TO: Mercedes-Benz Dealer Principals, General Managers, Sales Managers, Service Managers, Parts Managers	FROM: Gregory Gunther, Department Manager, Vehicle Compliance and Analysis, Engineering Services
RE: Emission Modification Notification – [[2020050026]] MY 12-13 S350 BlueTEC 4MATIC Update – Emission Modification Category (EMC) #6	DATE: May 27, 2022

Campaign No. 2020050026, November 2021

SUBJECT: **Model S-Class diesel vehicles (V221 platform)**
Model Year 2012-2013
Modification to the emission control system

Figure 2

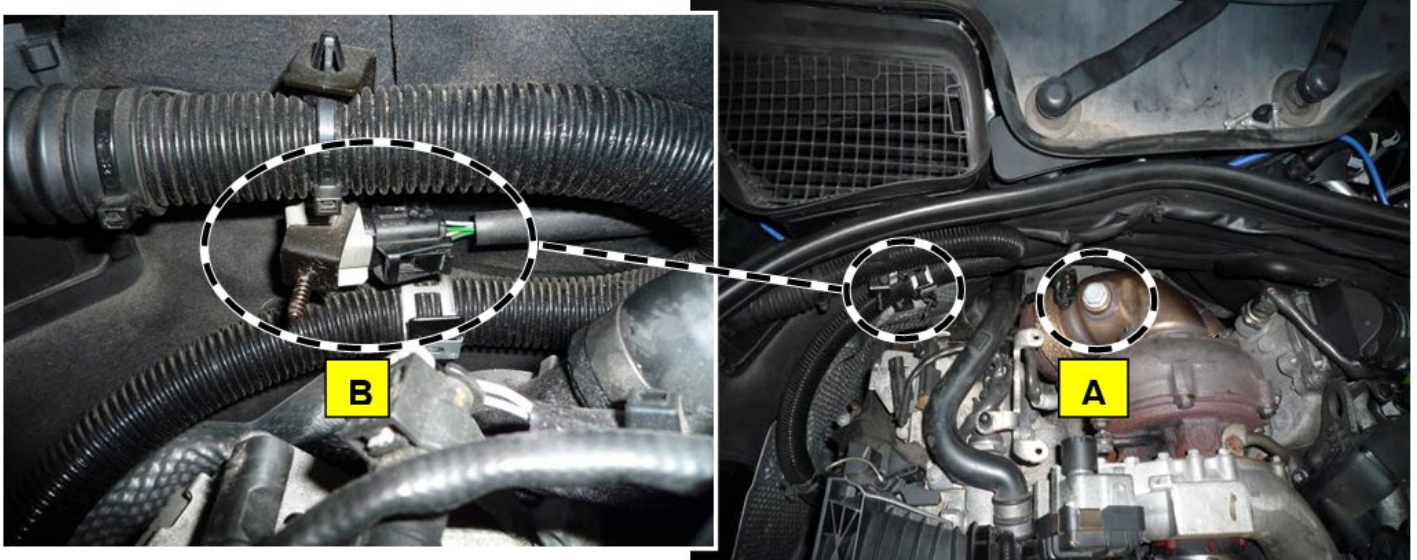
2. Disconnect battery ground (AR54.10-P-0003EW).
3. Replace coolant thermostat (AR20.10-P-2460SXI).
 - i** If possible, do **not** loosen the oil leak lines as it is quickly damaged. It is better to disconnect the lines on the fuel filter.
 - i** If the oil leak line needs to be loosened, absolute caution should be exercised.
4. Replace components of the exhaust system (DPF/DOC unit and SCR catalyst).
 - i** For basic data see AR49.10-P-7100SXI, AR14.40-P-1000SXI.
 - i** All labels on the DPF/DOC unit and SCR catalyst must be removed.
5. Remove the oxygen sensor.
 - i** For basic data see AR07.04-P-0080SXI.
6. Install screw plug (N 007 604 018 109) and sealing ring (A 021 997 62 45) on the turbocharger (Nm 50, Figure 2,A).
 - i** The oxygen sensor is no **longer** needed!

7. Install the plug housing (A 000 545 40 39) on the electrical connection for the oxygen sensor (**Figure 2,B**).

i The electrical connection for the oxygen sensor is *no longer* needed!

Figure 3

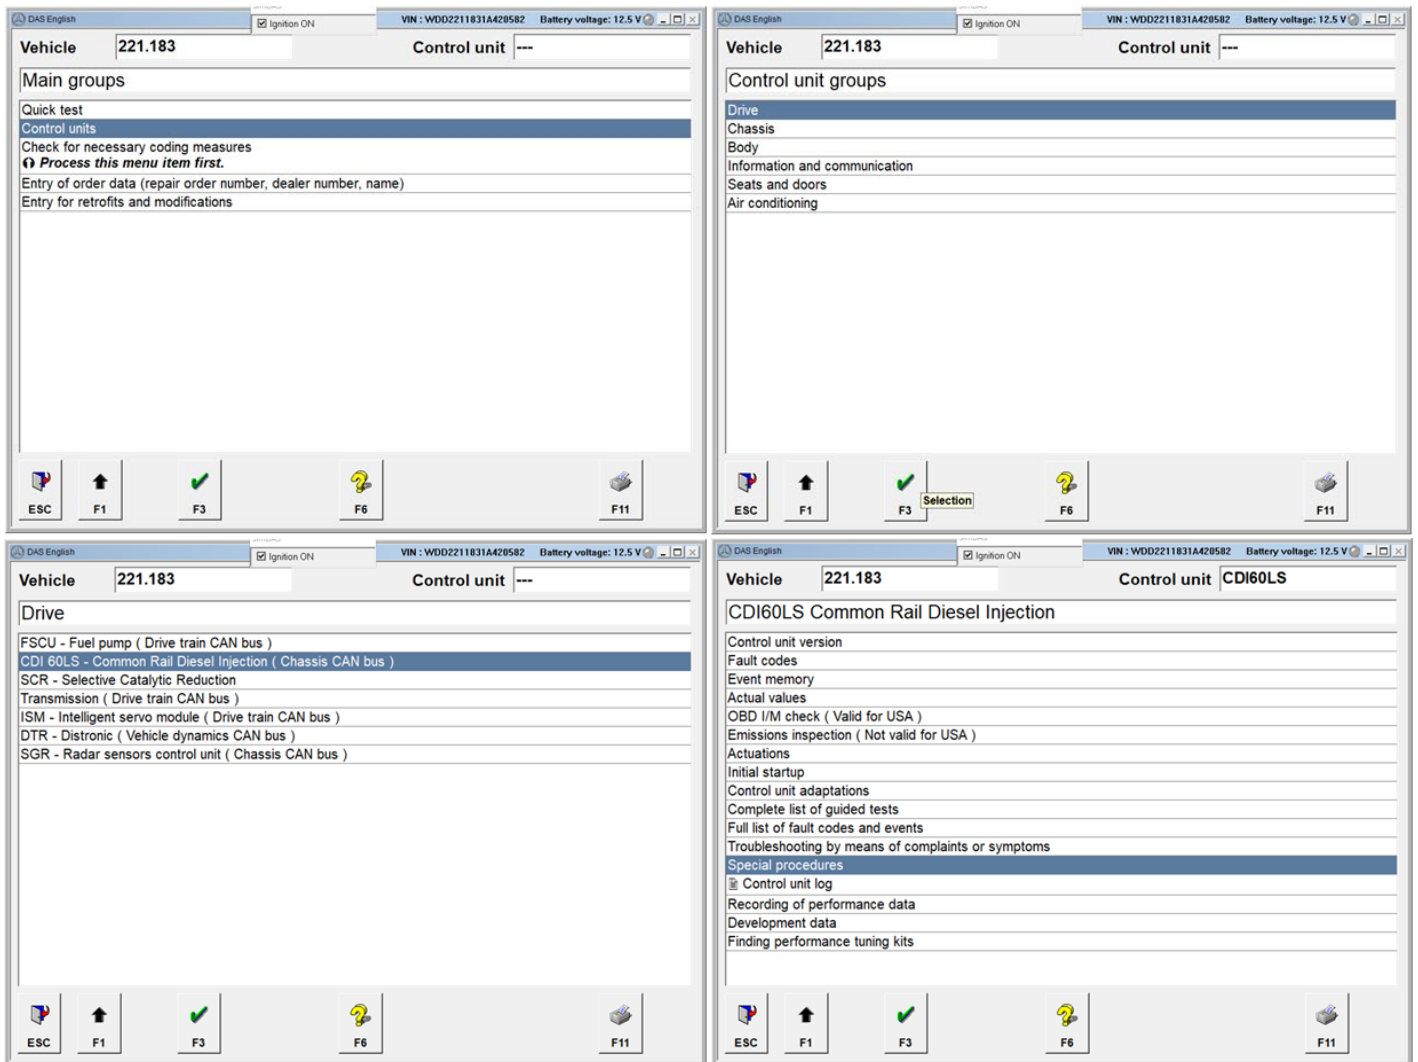
8. Replace both NOx sensors (**AR14.40-P-20380GE**).

i NOx sensor upstream of SCR catalyst (A 000 905 58 12 80)

NOx sensor downstream of SCR catalyst (A 000 905 58 12 80).

i The wire on the **old** NOx sensor should be cut off to facilitate removal and to ensure that it is not reused (**Figure 3**).

Figure 4

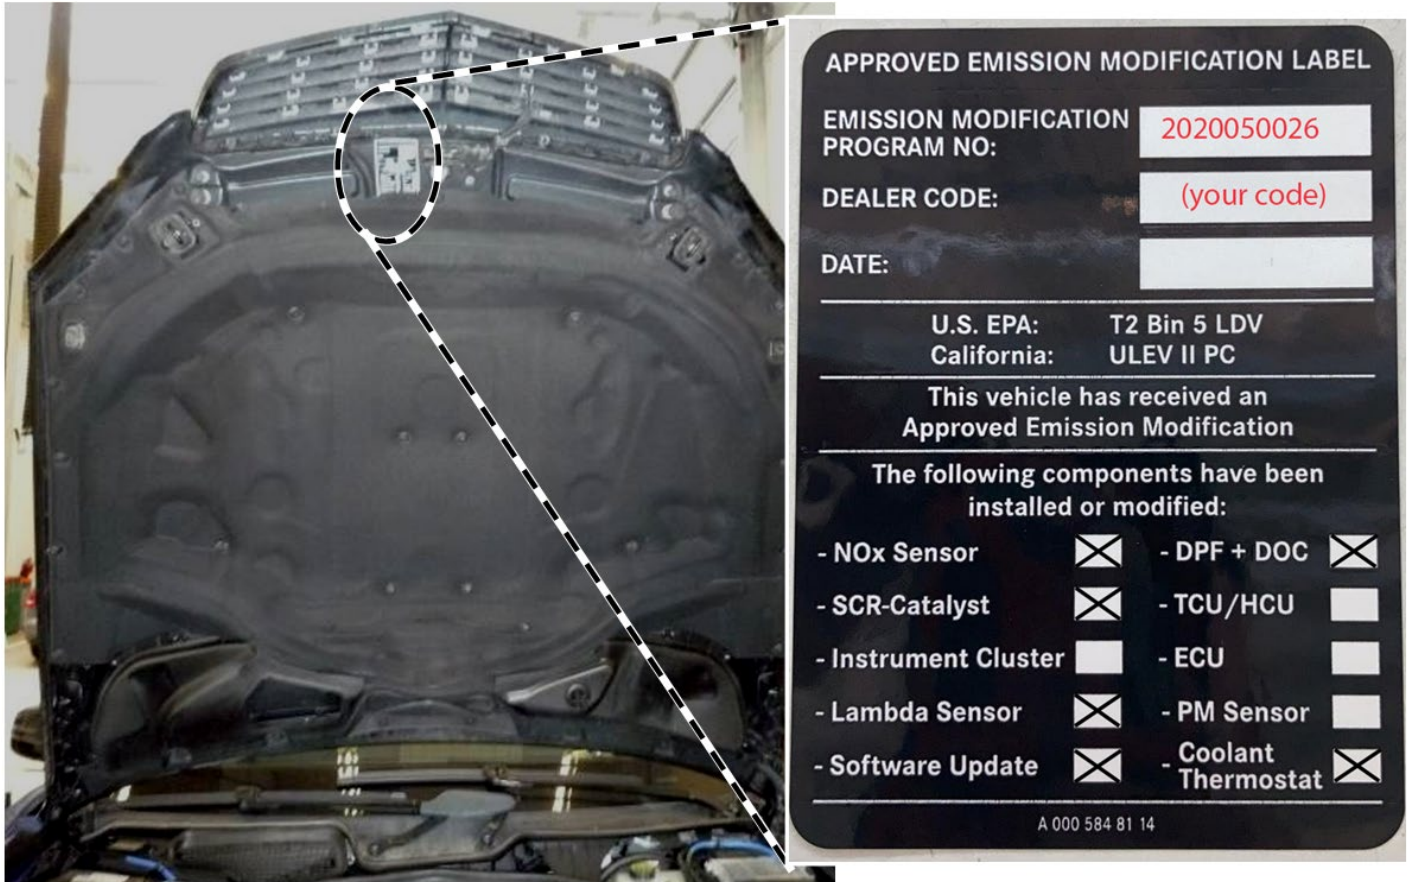
12. Clean the bonding area surface of the hood and apply the adhesive label (**Figure 4**).

i The fields on the label must be filled in accordingly. Please use black permanent marker. Refer to XENTRY procedure.

i The adhesive label can be attached to the hood **during** the software update of the control units.
